**ADDENDUM NO. 3
CITY OF PEORIA
MacArthur Highway Improvement Project
June 5, 2025**

Re: Addendum for Bid Package, **MacArthur Highway Improvement Project**, Peoria, IL

F.A. RTE.	SECTION	COUNTY	TOTAL SHEETS	SHEET NO.
		PEORIA	405	144
CONTRACT NO.				
ILLINOIS FED. AID PROJECT

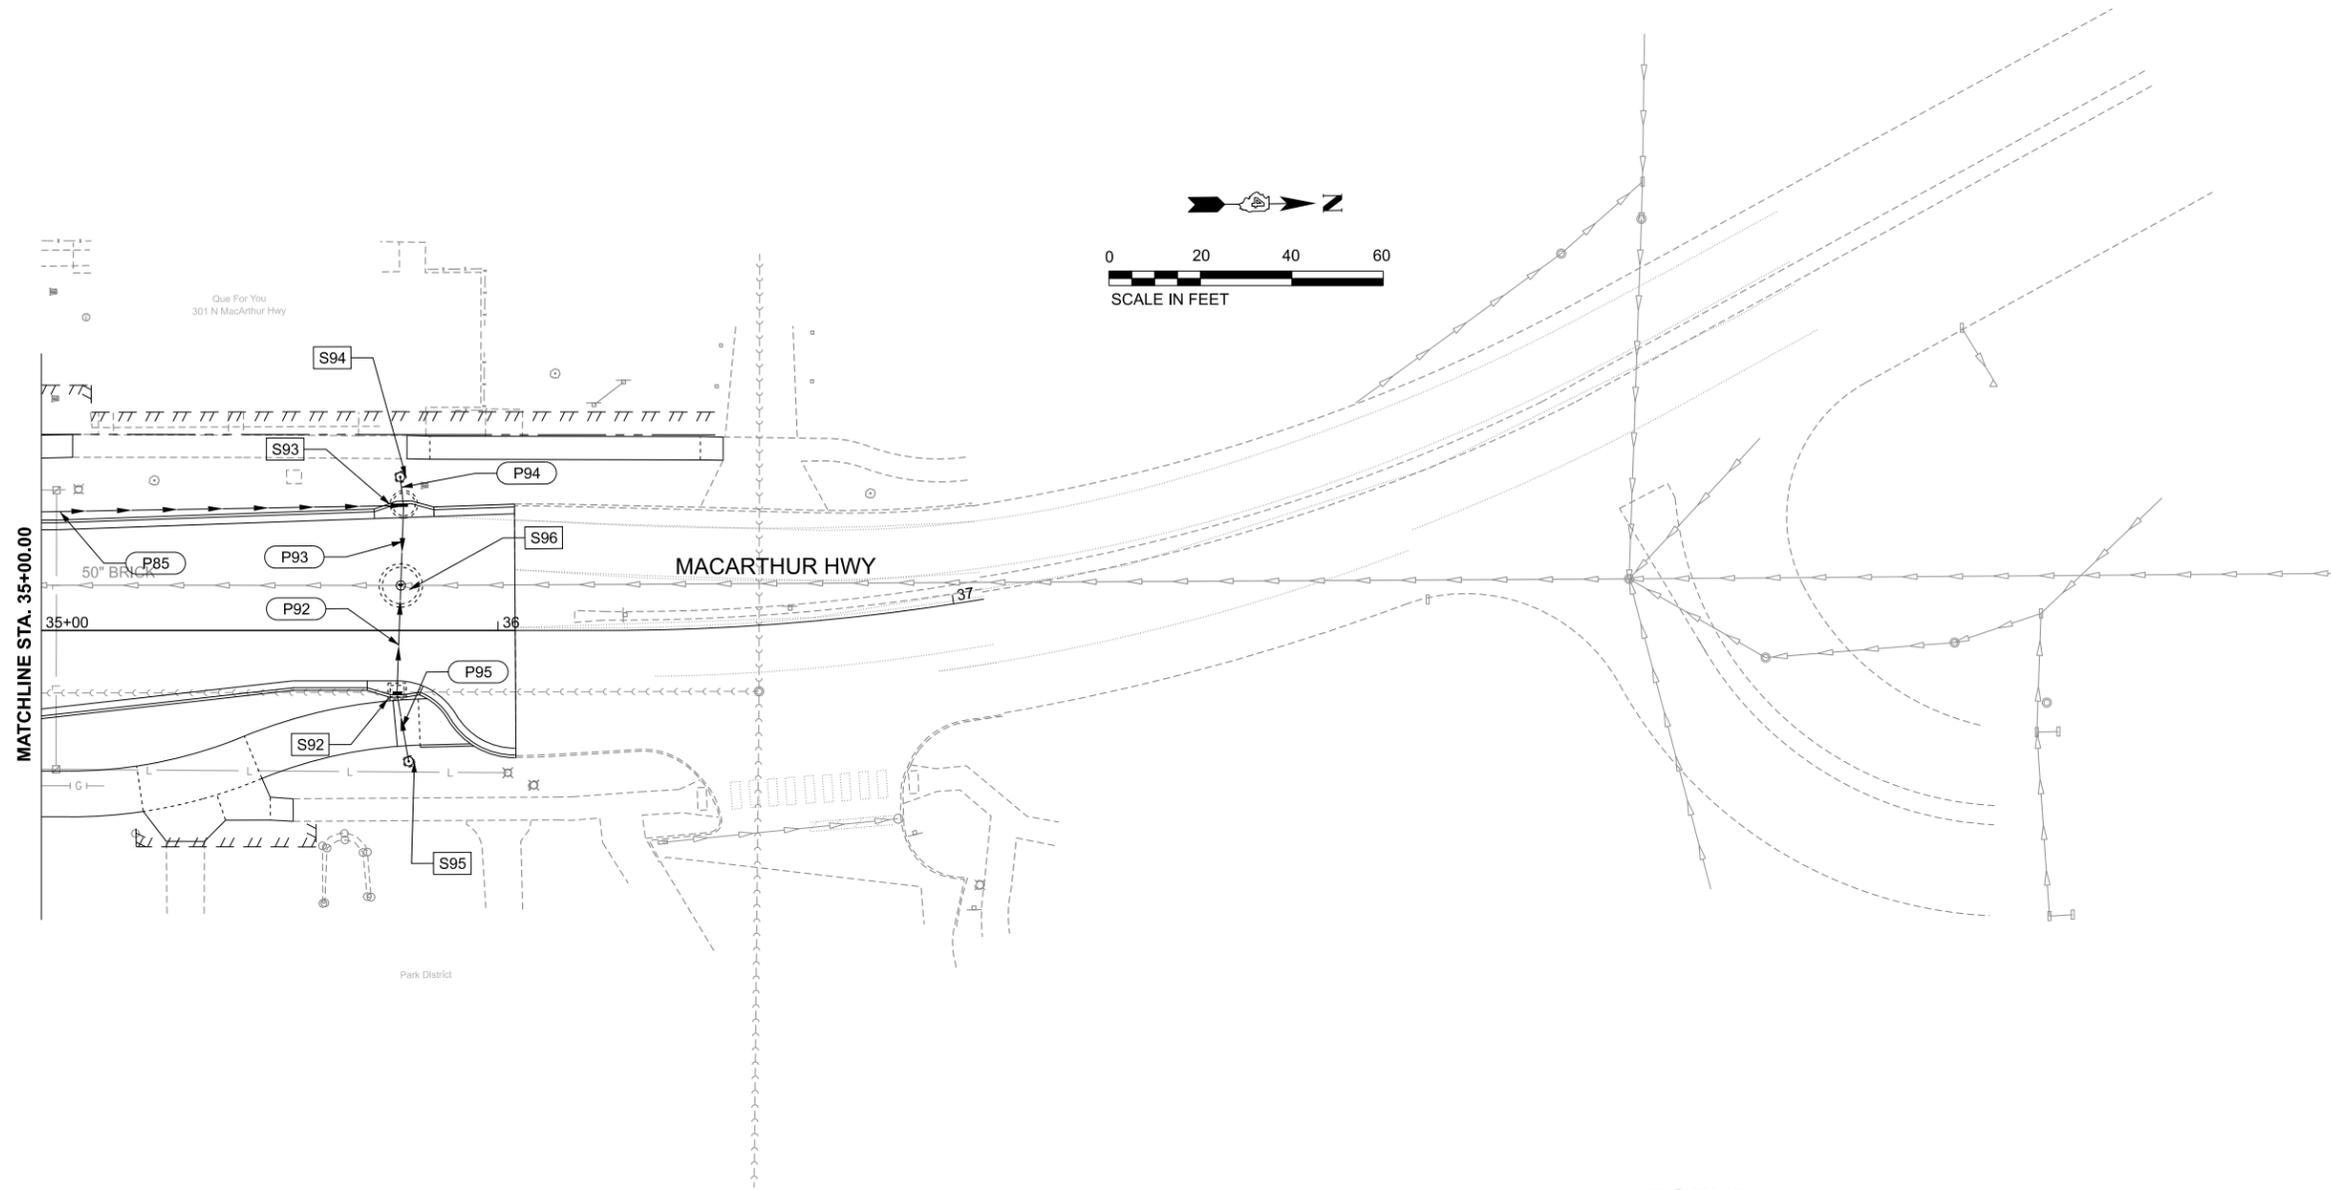
6. Correction to typical sections – subbase callout under INCIDENTAL HMA changed from 4 INCH to 6 INCH.
 - a. Typical sections (sheets 23, 24, 29, 32)
7. Correction to bottom elevation of S96

- a. Drainage Plans (sheet 144)

Question: I think the bottom elevation for manhole special # S96 shown in the table on page144 at 502.51 is incorrect. The cross sections in this area show the top of the pipe around this elevation. This will make a big difference on this large special manhole. Also an 8' manhole would not work if the 502.51 elevation is correct.

Response: The bottom elevation has been adjusted to the approximate invert of the existing storm sewer at this location. Invert of the existing storm sewer is based on City Stormwater GIS data.

F.A. RTE.	SECTION	COUNTY	TOTAL SHEETS	SHEET NO.
		PEORIA	405	185
CONTRACT NO.				
ILLINOIS FED. AID PROJECT

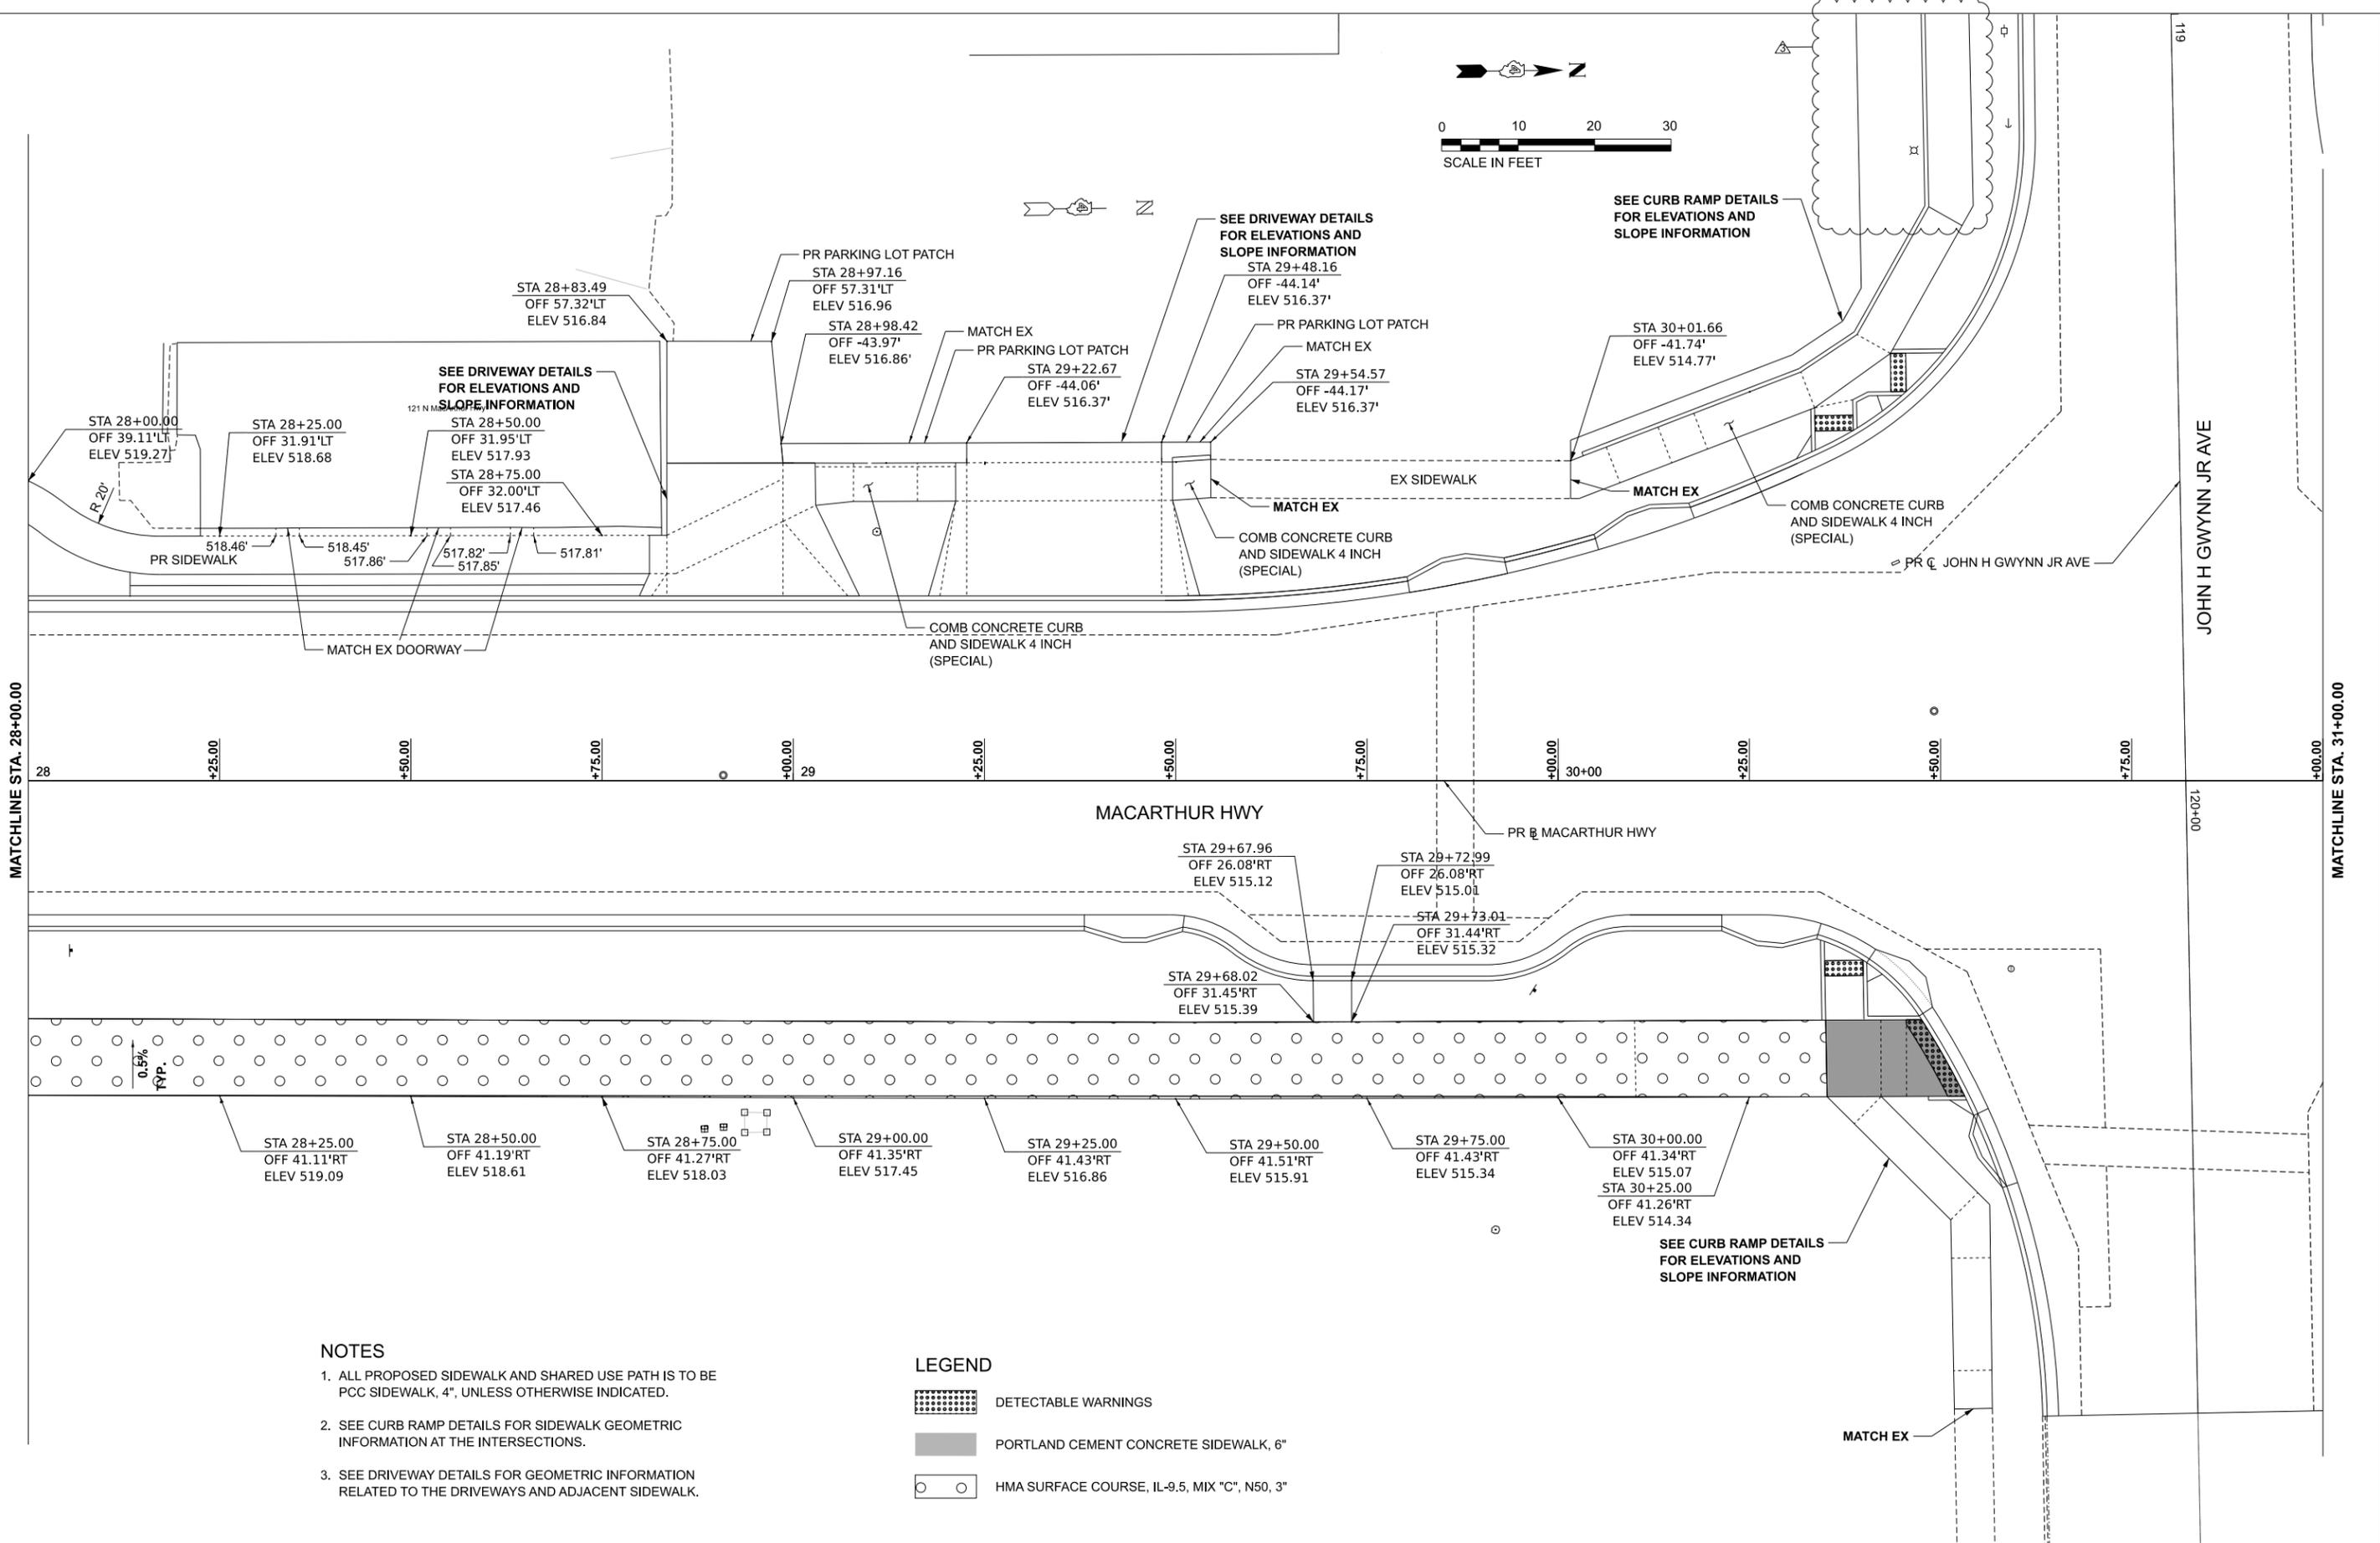
- e. Plan and Profiles (sheets 55 & 66)
 - f. Erosion Control and Landscaping (sheet 121)
 - g. Sidewalk Plan (sheet 185)
 - h. Curb Ramp Detail (sheet 202)

F.A. RTE.	SECTION	COUNTY	TOTAL SHEETS	SHEET NO.
		PEORIA	405	240
CONTRACT NO.				
ILLINOIS FED. AID PROJECT

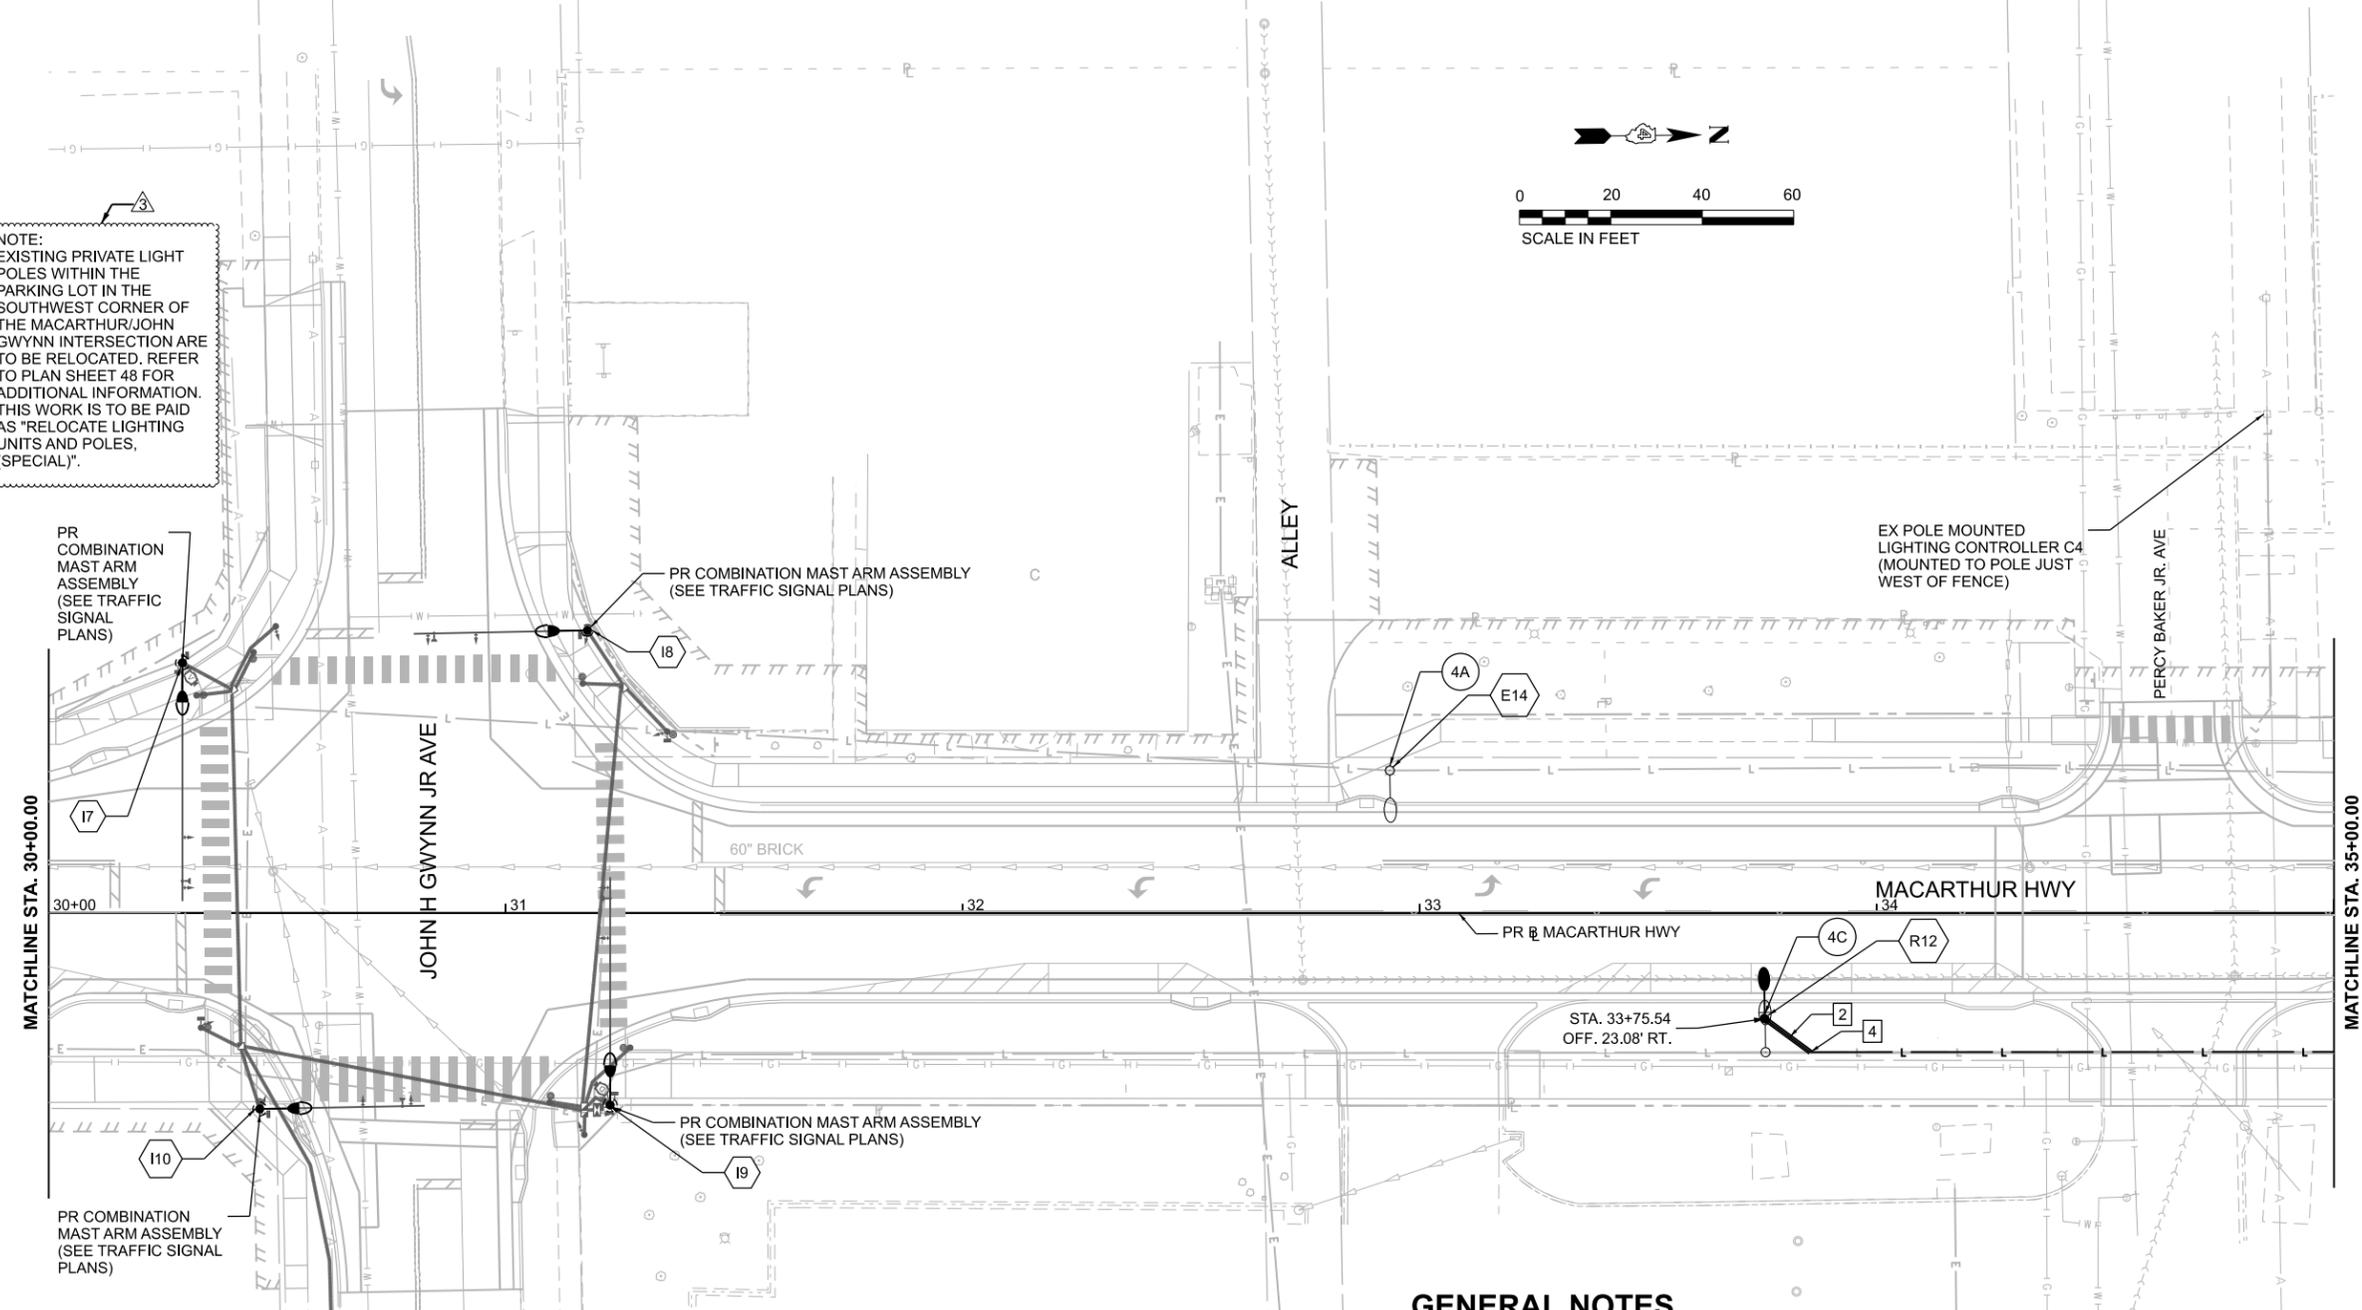
- a. Added note to clarify items paid as RELOCATE EXISTING LIGHTING UNIT (SPECIAL) (sheet 234)
 - b. Added note to clarify item paid as RELOCATE LIGHTING UNITS AND POLES, (SPECIAL) (sheet 240)

A note has been added to plan sheet 240 to clarify RELOCATE LIGHTING UNITS AND POLES, (SPECIAL). This points to sheet 48 – Notes A and B, which also address this item. The quantity has been increased to 2 EACH. This item refers to the existing wood poles with lights on them in the parking lot in the southwest corner of MacArthur and John Gwynn.

NOTE:
 EXISTING PRIVATE LIGHT POLES WITHIN THE PARKING LOT IN THE SOUTHWEST CORNER OF THE MACARTHUR/JOHN GWYNN INTERSECTION ARE TO BE RELOCATED. REFER TO PLAN SHEET 48 FOR ADDITIONAL INFORMATION. THIS WORK IS TO BE PAID AS "RELOCATE LIGHTING UNITS AND POLES, (SPECIAL)".
